Title - Sujet HVAC Upgrade	
Solicitation No. - N° de l'invitation F1700-164101/A	Amendment No. - N° modif. 002
Client Reference No. - N° de référence du client F1700-164101	Date 2017-03-23
GETS Reference No. - N° de référence de SEAG PW-\$PWY-026-8013	
File No. - N° de dossier PWY-6-39353 (026)	CCC No./N° CCC - FMS No./N° VME
Solicitation Closes - L'invitation prend fin at - à 02:00 PM on - le 2017-04-13	
F.O.B. - F.A.B. Plant-Usine: <input type="checkbox"/> Destination: <input checked="" type="checkbox"/> Other-Autre: <input type="checkbox"/>	
Address Enquiries to: - Adresser toutes questions à: Yi (PWY), Patty	Buyer Id - Id de l'acheteur pwy026
Telephone No. - N° de téléphone (778) 919-2578 ()	FAX No. - N° de FAX (604) 775-6633
Destination - of Goods, Services, and Construction: Destination - des biens, services et construction: DFO - Pacific Biological Station - Nanaimo, BC

Amendment 002 has been raised to incorporate mandatory site visit attendee names, questions and answers and Drawing MSK1.

DATE	15/03/17
BY	MSK
FOR	MSK
PROJECT	PACIFIC BIOLOGICAL STATION PUMP RECOVERY PIPING PUMP SHELTER LOCATION

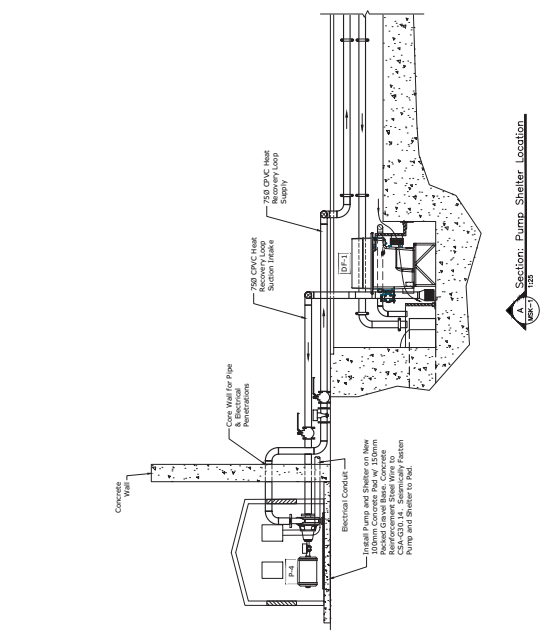
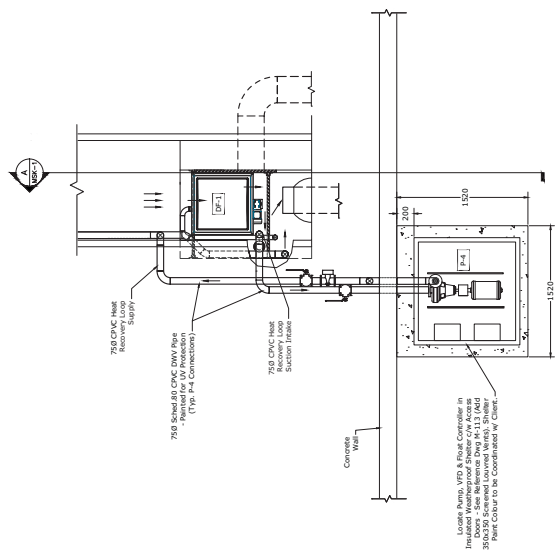
7) *Please Clarify – Is the pad and enclosure shown on M-9 (Detail4,A, and C) to be included in the quote or will this be provided by others?*

The pad and enclosure are to be included in the quote. Note that pad and enclosure location has changed to the lawn area outside of the courtyard. See Drawing No. MSK-1.
